Final Drainage Report
Amendment No. 1
Beacon Lite Road Stockpile
El Paso County, Colorado

EDARP File No. CDR261

DRAINAGE PLANS – AMENDMENT NO. 1

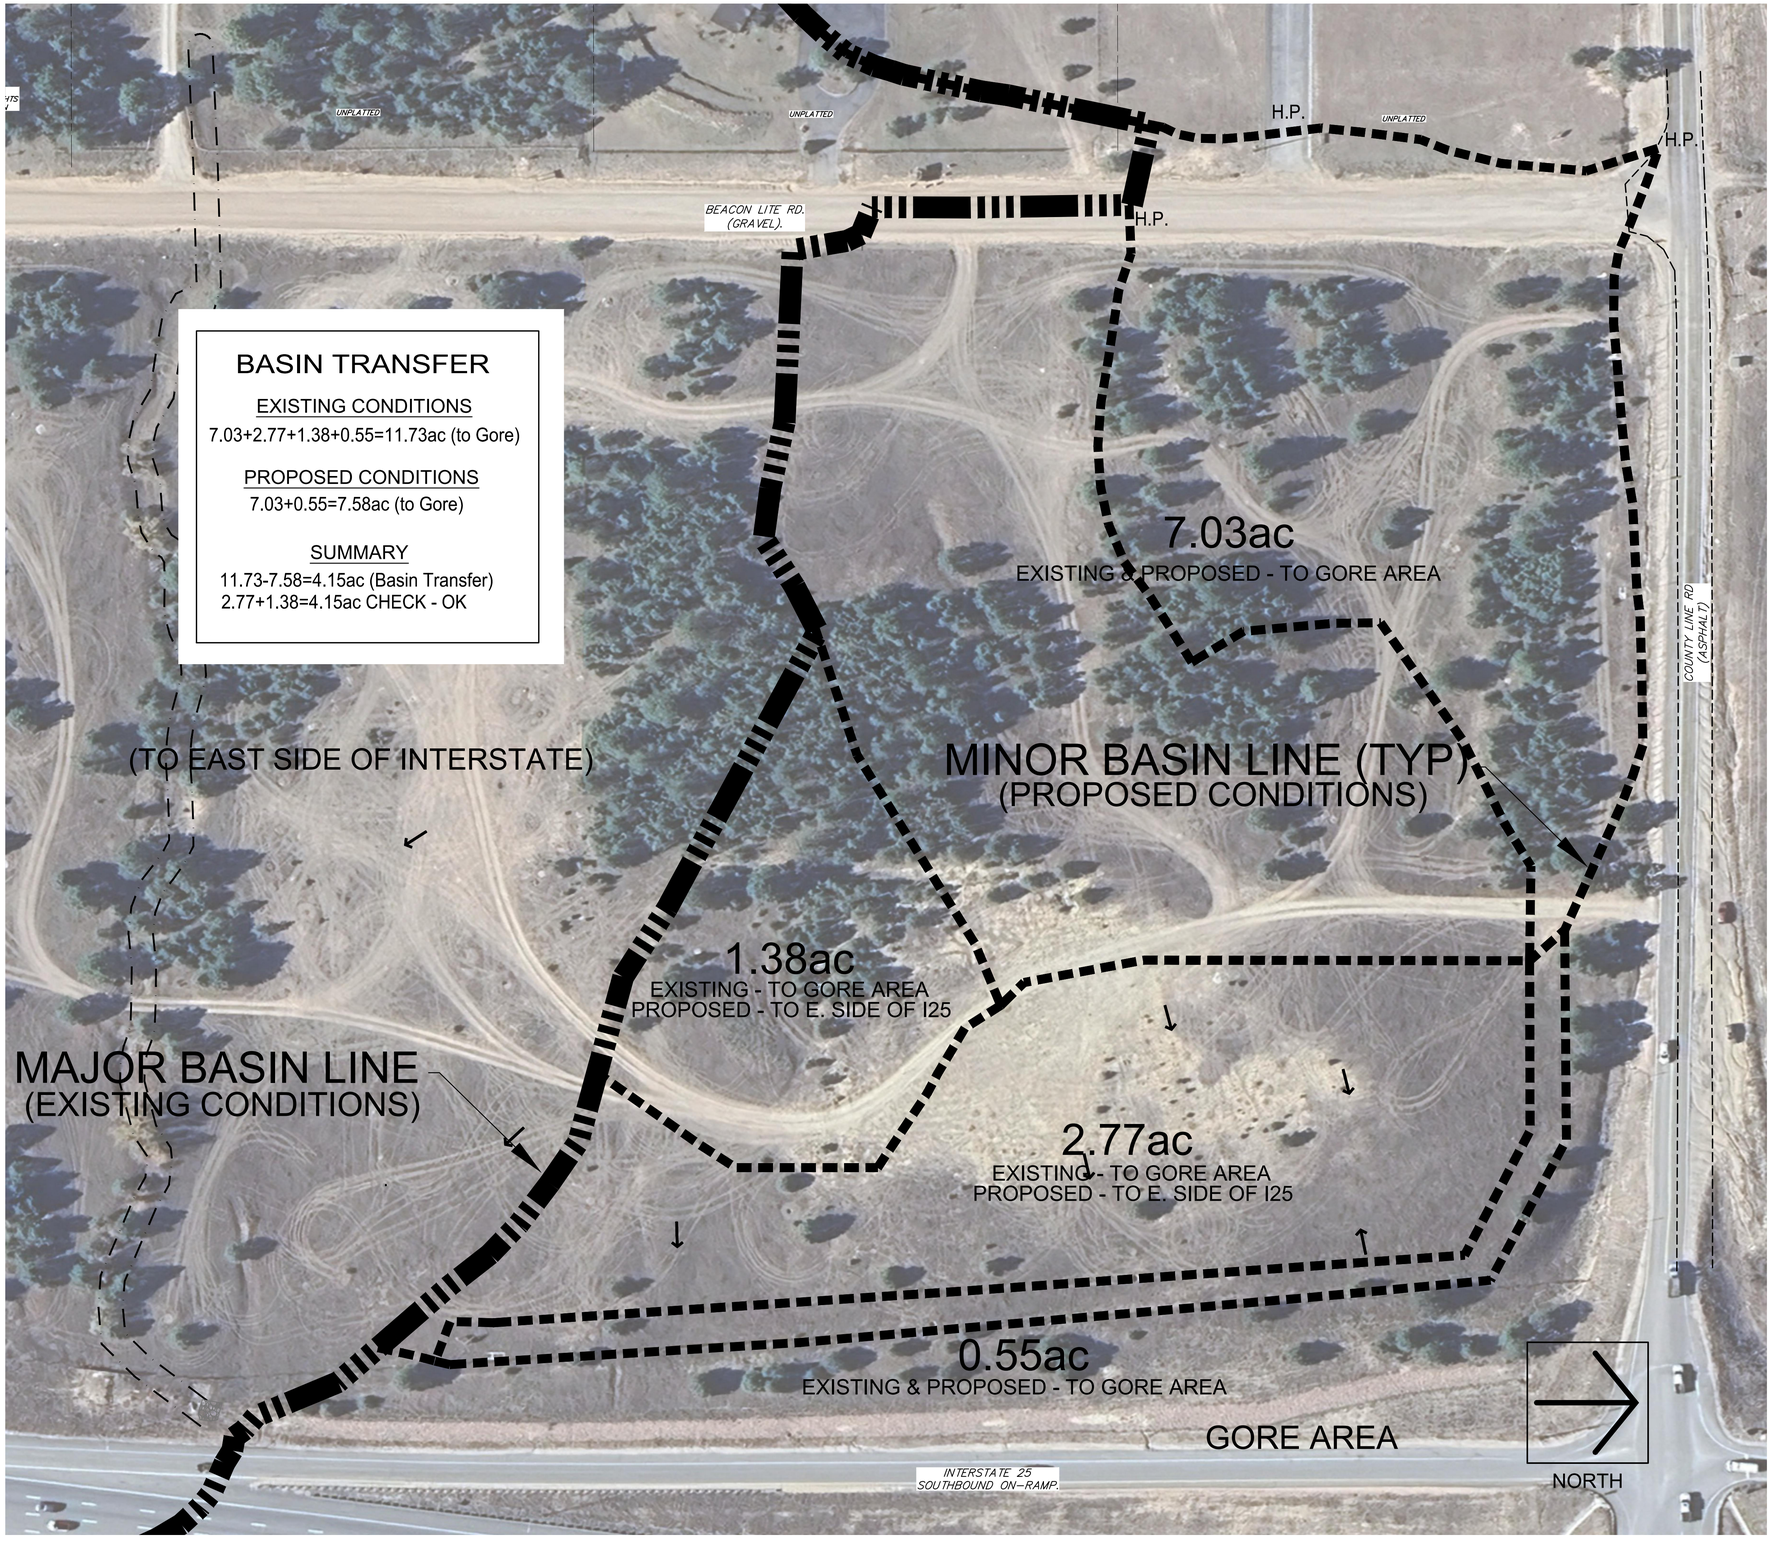
You don't need to say "(Disturbed)" here because all areas shown on these calcs should be for disturbed areas in each basin. So please delete "(Disturbed)" and update all SPA area numbers to only include the areas of disturbance in each basin.

Update inputted SPA areas per my comment on the previous page.

Unresolved comment from Review 5:
What about Basins B2 and B3? There is disturbances in those areas that arent trib to the pond that appear that they could be treated via SPAs.

Review 7 update: You have now included B3, but are still missing B2. I see that B2 is now on the previous page for the North area, but the area inputted (5,227) is not close to the total disturbed area of B2 North + B2 South, which is around 3,900 + 20,300 = 24,200. Please measure the B2 South disturbance and include it as an SPA on this sheet.
